Comments Received:

Response to Comments:

Subject: Rockville Trails Preserve

Comments on Initial Study and Mitigated Negative Declaration

Photographs from behind adjacent properties demonstrating a lack of existing service roads

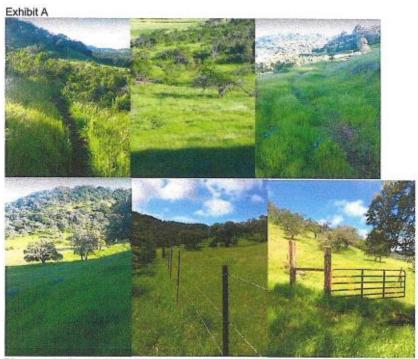
1. Part 1 of this document discusses road and trails, including roads that will be used as "service roads" only, not intended for public uses. On page 19 of Part 1 the last sentence of the first paragraph under the Roads and Trails heading states that "a buffer of 150 feet from the property line for new public trails is part of the Planned Policy Overlay." We request that the construction of any new roads, whether designated as service roads or for public use be restricted in the buffer zone and that verbiage stating this is added to the Planned Policy Overlay. Table 3. Roads and Trail Design Standards provide information showing that roads, due to their larger size and their usage, have a much greater potential impact on the environment than small trails. It stands to reason therefore that this buffer zone protection should include new roads whatever their intended use. On Page 2, it cites "Existing roads for service only" with 2.58 miles. No new service roads are mentioned in Table 2. Figure 7 of that same document does not show any service roads on the Eastern portion of the Preserve. However, on Exhibit A Appendix A in part 2 of the document, there is a service road that is marked on the Eastern portion of the Preserve going behind our property and adjacent private property owners. There is no existing service road behind our properties. (See attached photographs Exhibit A). There are some narrow cow paths, some eroded areas which may have been caused by cattle, horses or ATVs used by the Bishop Ranch staff, or by activities of previous landowners prior to Solano Land Trust. These areas are intermittent and not contiguous to each

other for most of the designated area. The designation of these areas as a "service road" on Exhibit A Appendix A is very inaccurate when compared to other designated "service roads" in the Preserve. These other "service roads" generally fit the description in Table 3. Roads and Trail Design Standards. The standards indicate that services roads can be from 8-12 feet wide and can accommodate service trucks, such as the service road at the West Gate of the Preserve. We request clarification of these discrepancies and SLT's plan for any type of use, modification and limitation of use in the area they are designating as a "service road" on the eastern side of Rockville Trails Preserve. The eastern area designated as a "service road" is in no way a road compared with the other areas in the Preserve which are also designated roads and truly are roads. We request that the designation of" service road" be removed and that this area is described as what it really is if it must be shown at all on Exhibit A Appendix A I. It is cow paths, with eroded areas, interspersed with remints of old ATV trails which are only used by the cattle ranchers currently grazing cattle on the Preserve. If the eastern service road as shown in Exhibit an Appendix A is not to be developed in anyway in the future characterizing it as it really is and not with the "service road" designation would be an accurate representation, anything suggesting a contiguous road is inaccurate to say the least.

- 1. The service roads shown on the Policy Plan Overlay Development Map (Exhibit A to Appendix A) indicates all the existing roads and access-ways used by the Solano Land Trust, cattle rancher and PG&E on the property. In some locations, the road is a formerly graveled roadway from a previous quarry operation or stockyard; the roads may be scraped down to the rock surface and in some locations the access is unmaintained grassy or dirt roads or wide trails. Some of the access is actually wide trails used by farm trucks ad all-terrain vehicles. The service access on the eastern portion of the map is mostly the latter. No further improvements are expected to those service access other than general maintenance. As proposed, the Solano Land Trust, cattle rancher and PG&E staff will continue to use these paths for livestock operations, maintenance and research purposes. Also, as shown on the Policy Plan Overlay Development Map, this area would not be open to the public as most of the proposed public trails are within the center of Solano Land Trust's property. Both Figure 7 and the Policy Plan Overlay Development Map have been amended to show indicate service access.

Exhibit A with sensitive areas marked in red as previously designated by the Solano Land Trust

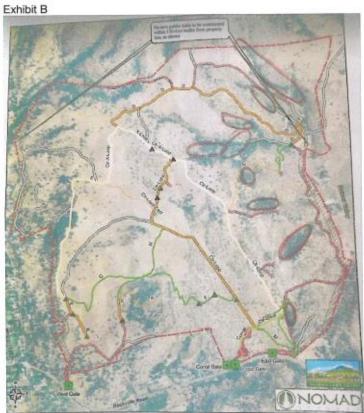
- 1) Part 1 of the document discusses road and trails, including roads that will be used for service only. One Table 2, it cites "Existing roads for service only" with 2.58 miles. No new service roads are mentioned in Table 2. Figure 7 of that same document does not show any service roads on the Eastern portion of the property. However, on Exhibit A to Appendix A in part 2 of the document, there are service roads that are marked on the Eastern portion of the property going behind our properties. There are no existing service roads behind our properties, only a few narrow cattle paths (see attached photographs Exhibit A). Therefore, any service roads on the Eastern portion of the Rockville Trails Preserve property would be new road construction. We would like clarification as to whether new service roads will be constructed behind our properties and the size and design of those roads/trails. Given the conflicting information in what is being presented in the Initial Study and Mitigated Negative Declaration Document regarding "service roads", we would also like to invite any members of the Solano County Department of Resource Management to visit our property and view the area.

- 2) The document discusses a "buffer" of 150 feet from the property line that would not be violated for future public trails. We would argue that this buffer should be 300 feet to help mitigate noise pollution that occurs given the natural amphitheater effect that comes from the hills, as well as better provide for our safety and privacy. This is also more consistent with the "good neighbor" policies of other open space districts and land trusts in the Bay Area. We also feel that any new roads, in addition to trails, should be outside this buffer space. It is notable that the service roads designated on Exhibit A violate the designated 150 foot buffer in several places behind our properties.

- 3) If new service roads are planned to be built behind our properties, we would have serious objections to these being constructed. We do not see that the impact of this construction is addressed in the study documents, including concerns of erosion given the soil types, possible soil slides given the slope of the land, the effect of high volume seasonal creeks, the aforementioned noise pollution as well as the proximity of the service roads to previously designated environmental and cultural sensitive areas (see attached Exhibit B). Given the availability of an access point in bordering fencing on our property which we

would be willing to let be used, we fail to see the necessity of these service roads. The land has been grazed by cattle from the Bishop Ranch for approximately 30 years without service roads on the Eastern portion of the property. They have used horses and ATVs to round up their cattle. There are no public trails on that side of the property which would need to be accessed by service roads. We are concerned that these roads are trying to be established as a part of this document to be then used as public trails in the future without the need for a further impact study and without allowing us, as adjacent property owners, the ability to take issue in a public form against public trails behind our lands which, if built as per Exhibit A, would come within 150 feet of our properties in several areas. If these service roads are indeed planned to be constructed as per Exhibit A, we would insist that an environmental impact study be done.

- 1. Please see Response to Comment 1, Letter 5 above.
- 2. Please see Response to Comment 2, Letter 5 above.
- 3. As described in the Project, no new service roads will be constructed in along the eastern boundary of the Solano Land Trust property. The existing service roads, trails and paths will be maintained and used by Solano Land Trust staff, the cattle rancher and PG&E for research and maintenance purposes.
